August 30, 2021

## Product Change Notice - Awning fabric barbell keder

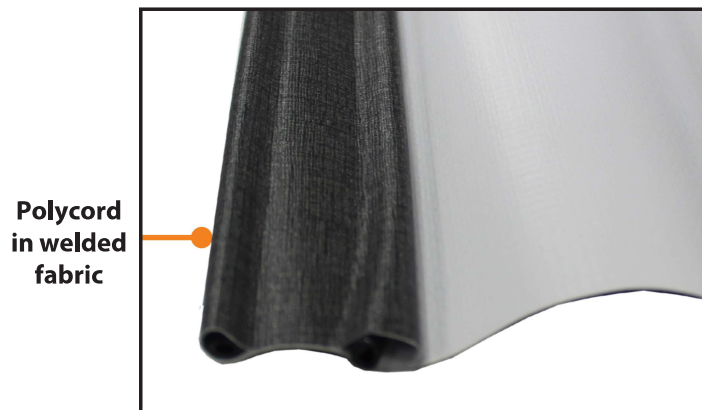
Please be advised, Lippert has designed a new awning barbell keder which will be utilized on our new automated awning fabric machine.

The barbell keder is the strip of material on the end of the awning fabric that slides into the wall of a unit and also provides the attachment point for the FABLED light strip.

The barbell keder will have an extra bulb on it eliminating the need for two welds. With the new barbell keder we will only need to have one weld on the fabric. There is no change in installation or operation with the improved production process. There is no price change and the awning fabric part number will not change.
